**HODGESVILLE PUBLIC SERVICE DISTRICT  
UPSHUR COUNTY, WEST VIRGINIA**

**MURPHY STATION ROAD EMERGENCY WATERLINE EXTENSION PROJECT**

**ADDENDUM #1**

**SEPTEMBER 1, 2023**

SHEET No.  
**D1**

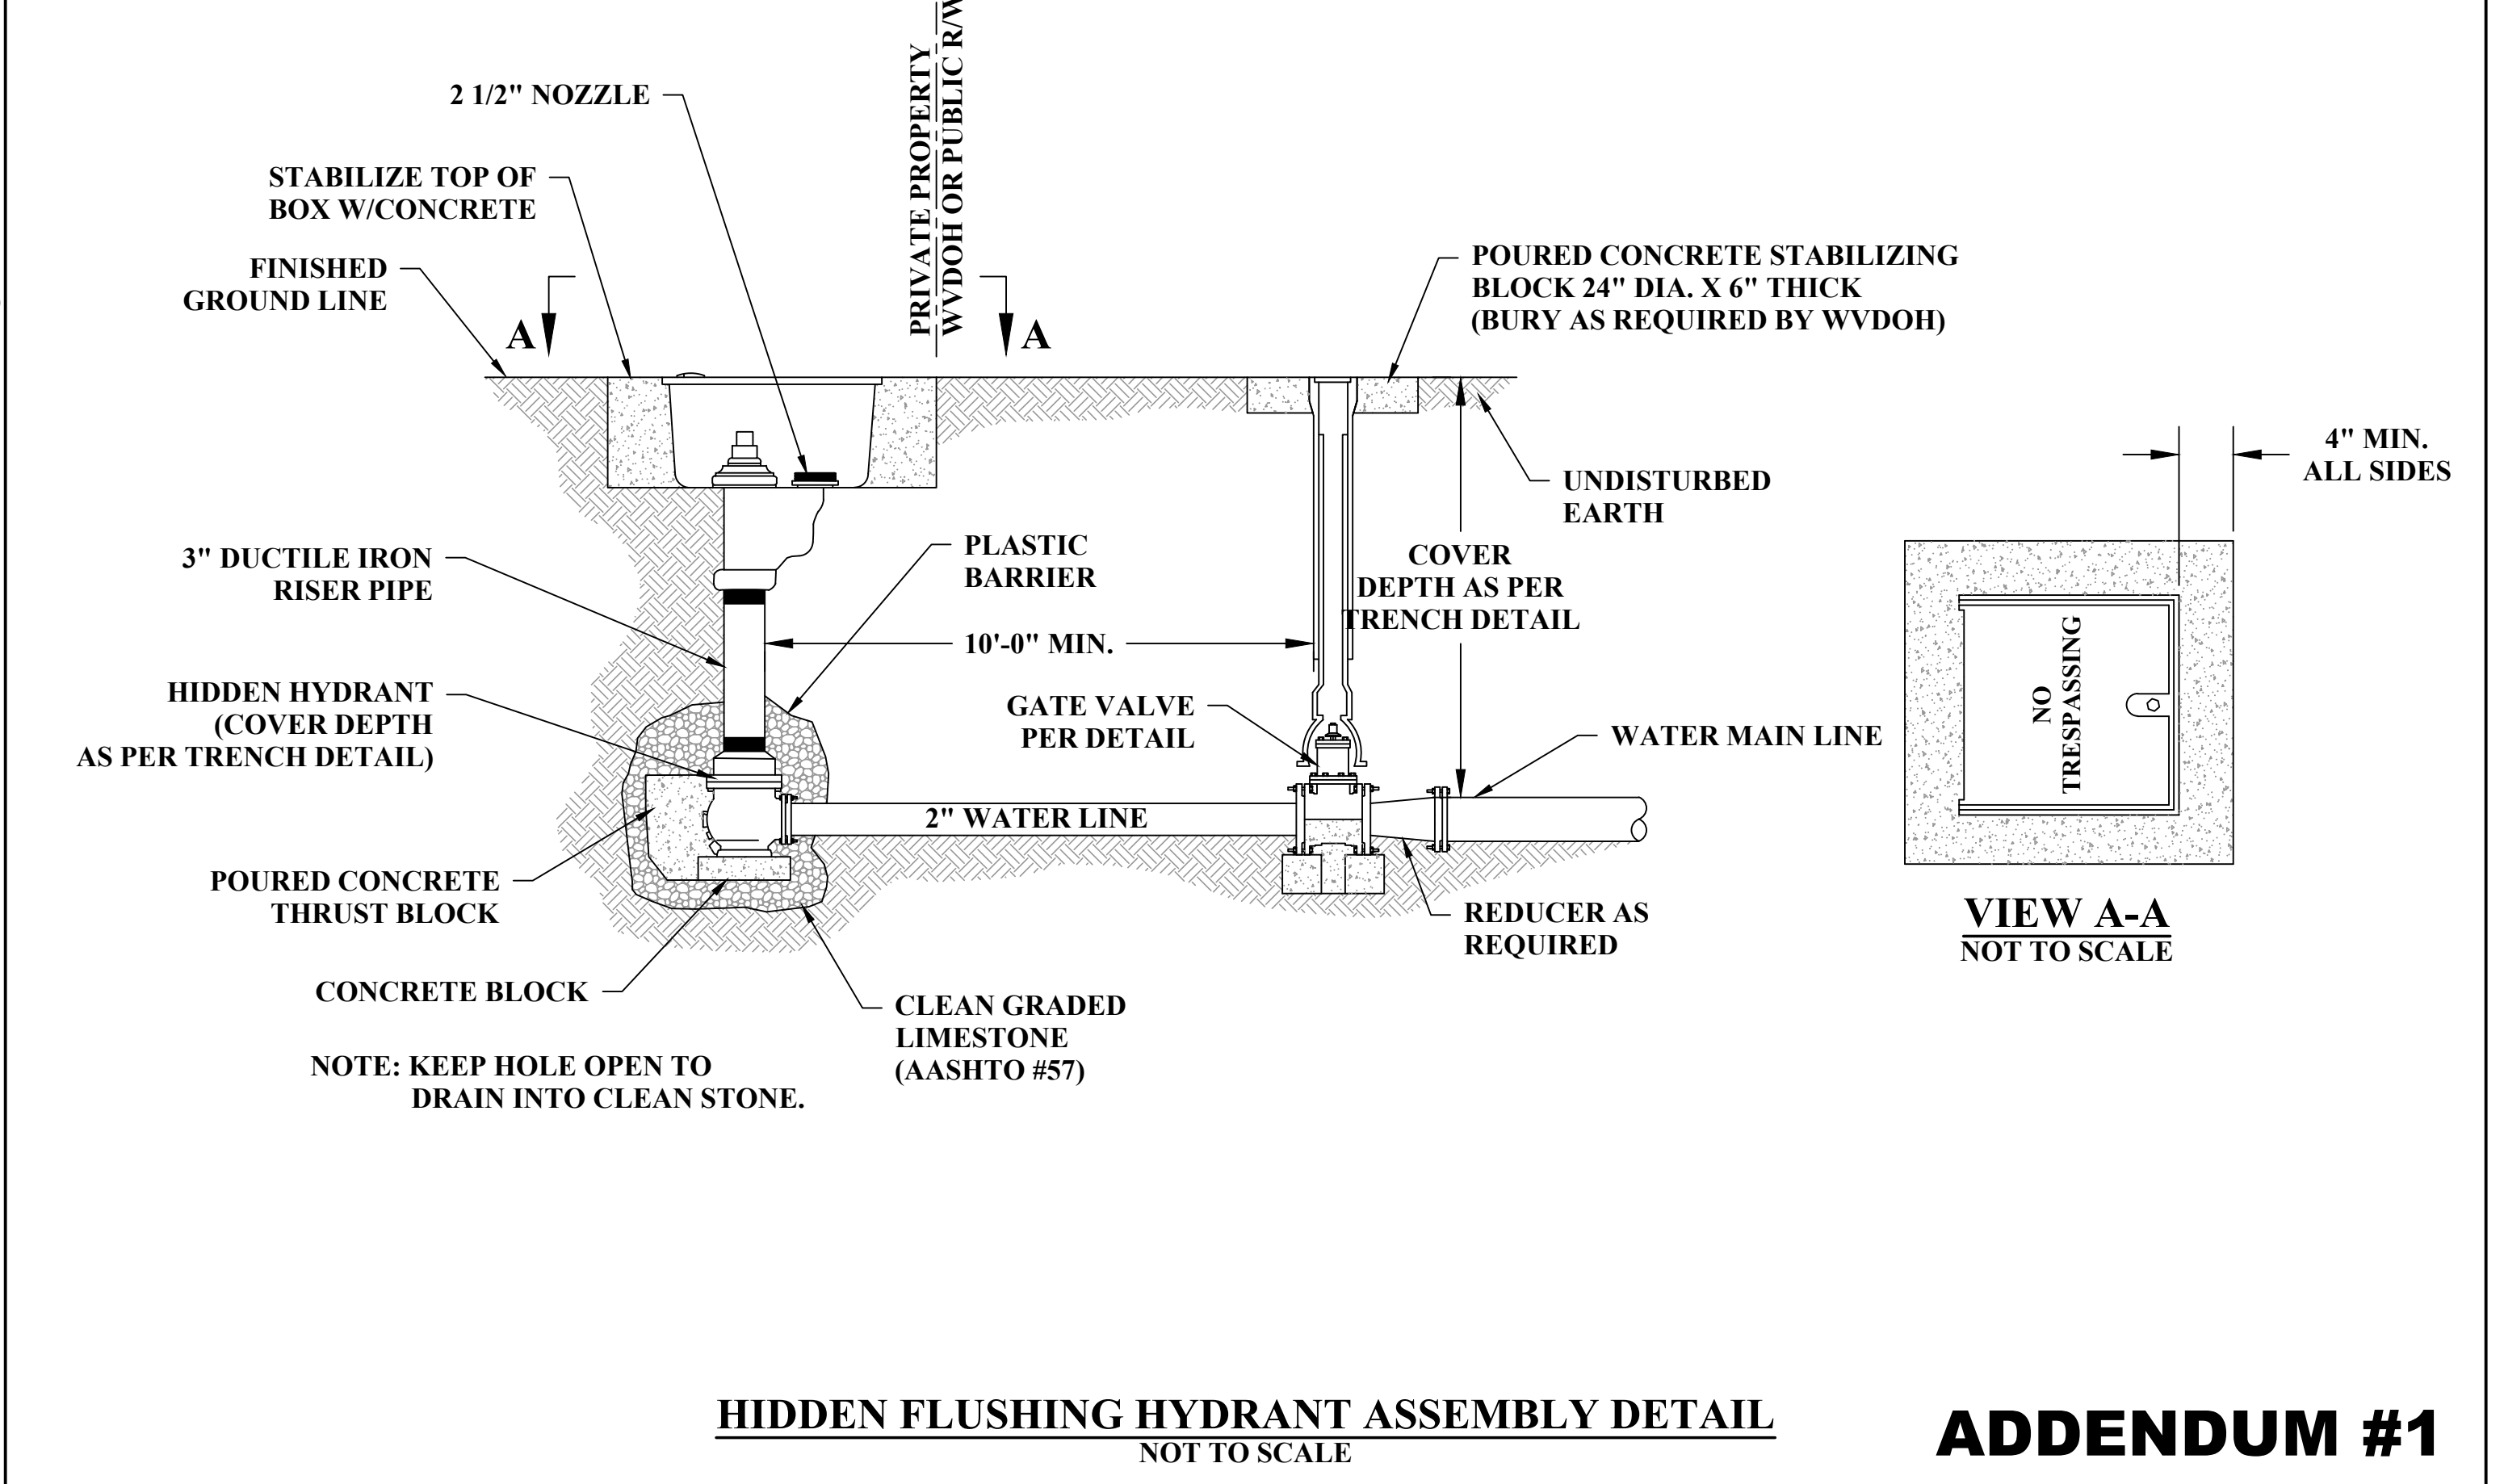
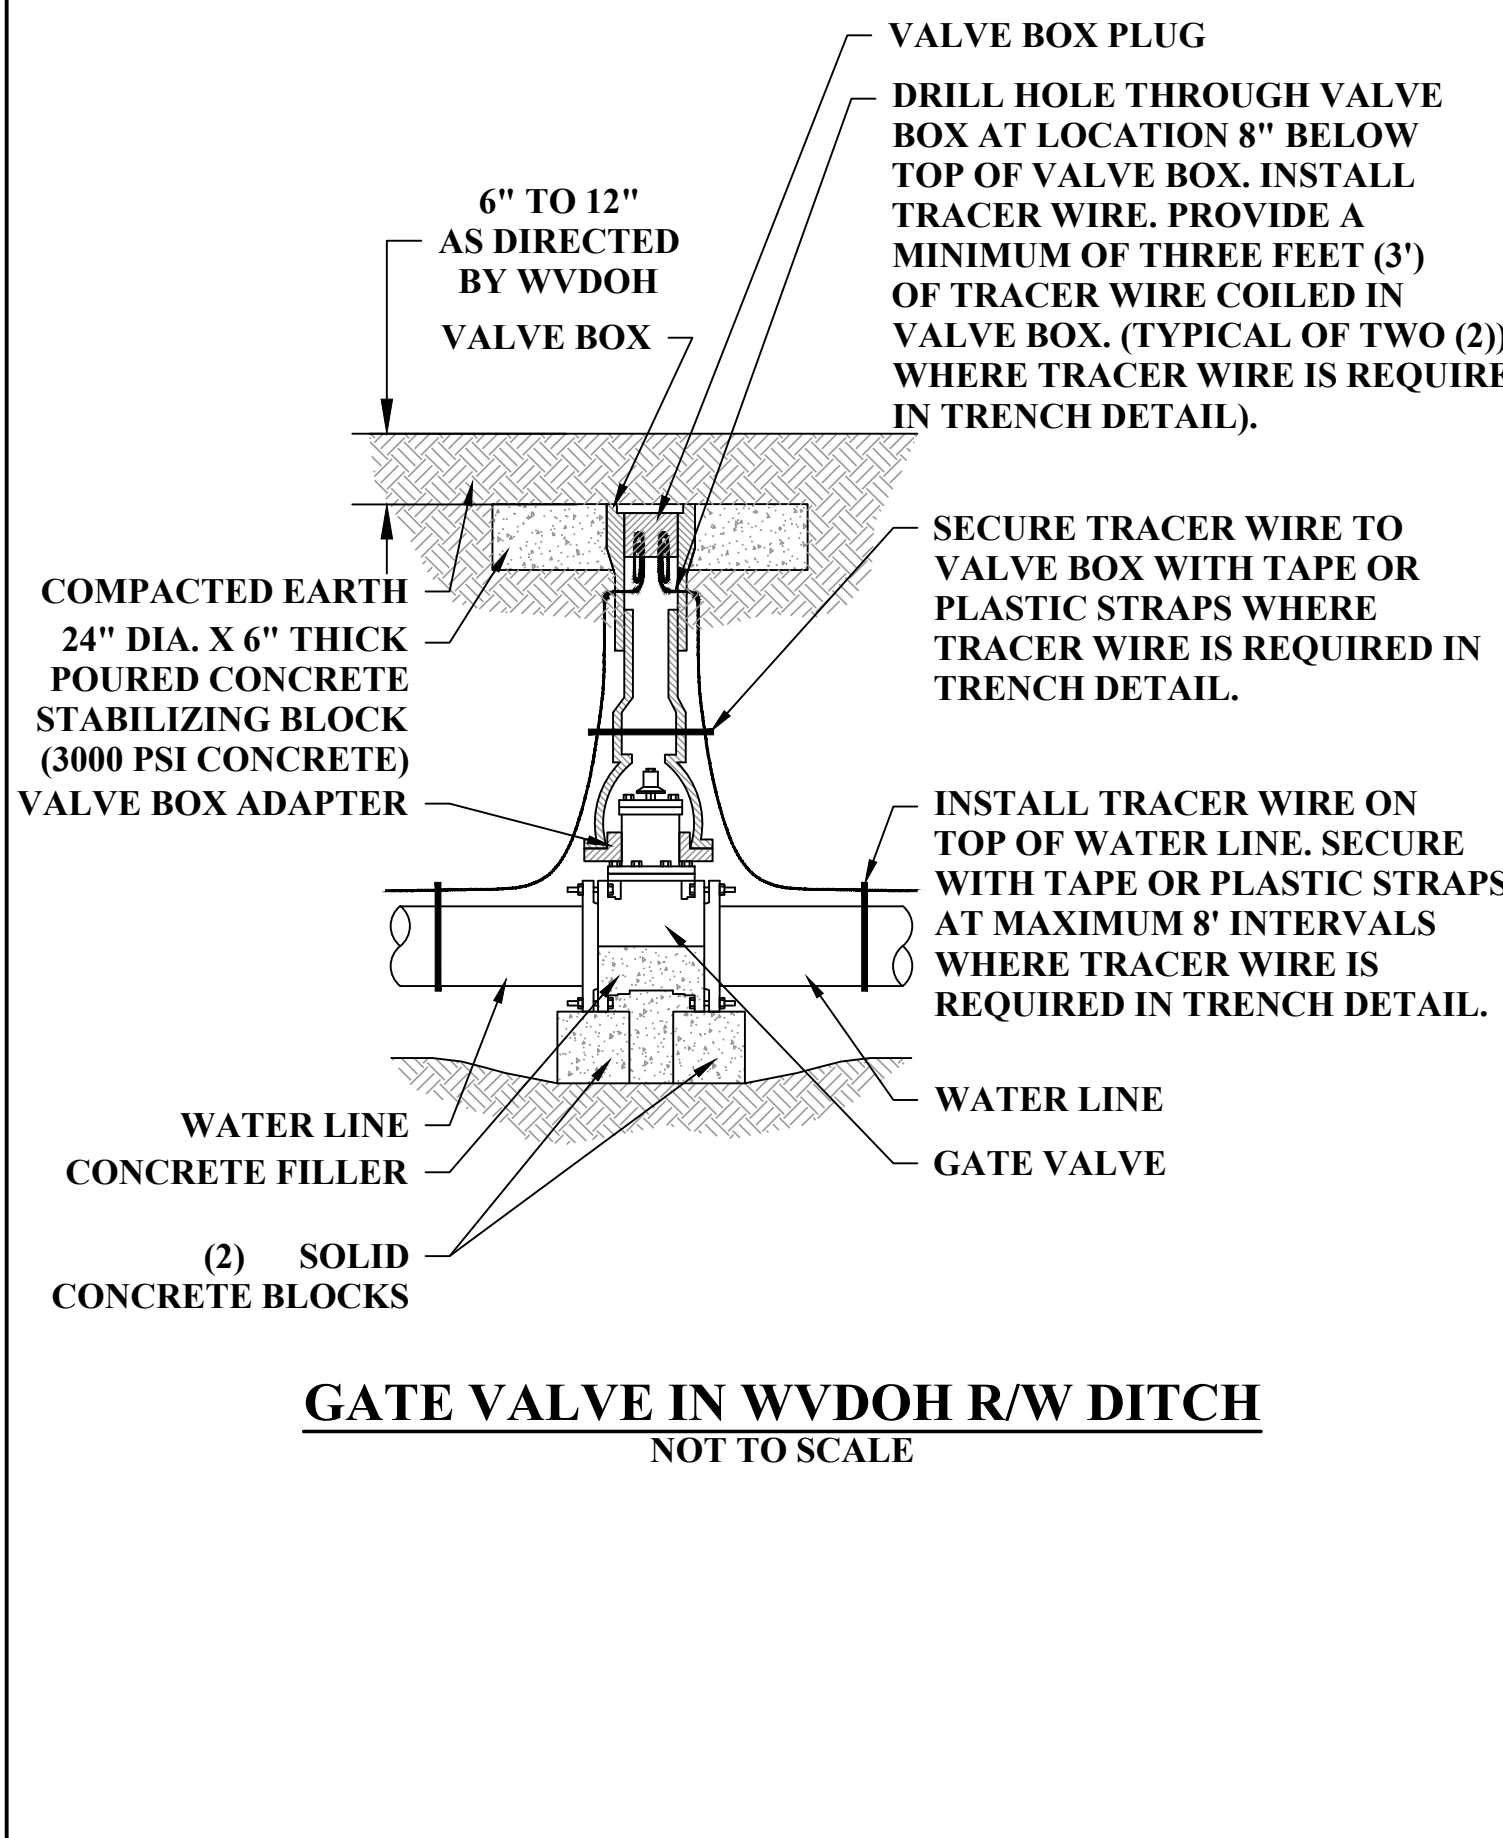
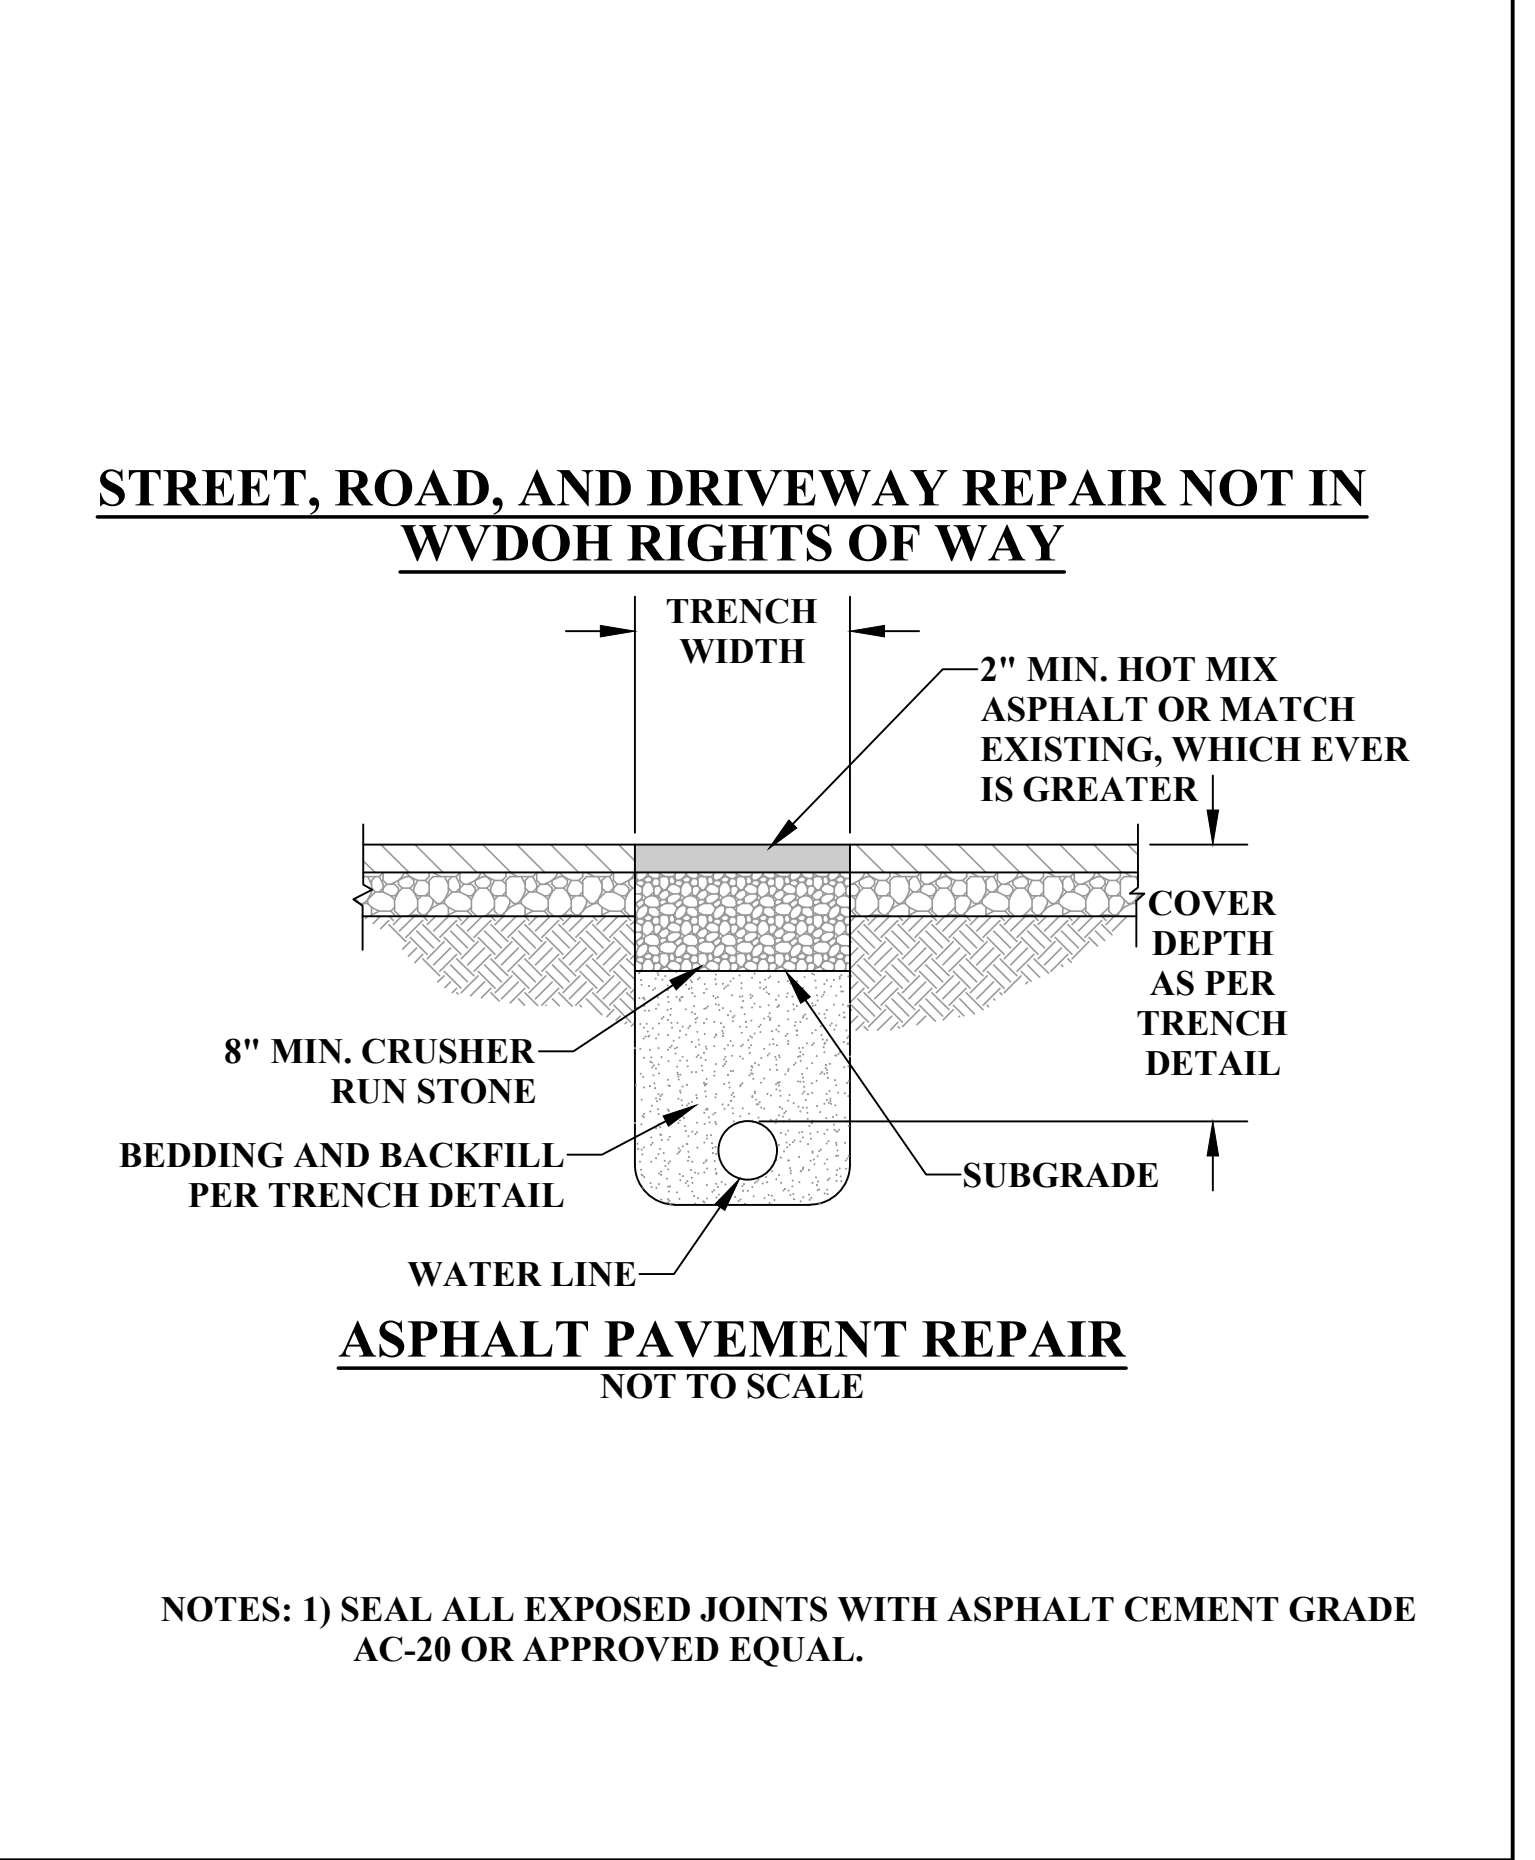
Can the engineer provide a waterline trench detail?

Yes, the trench detail has been added to sheet D1 under "Trench Detail." The revised Typical Water Detail Sheet #D1 is included with this Addendum.
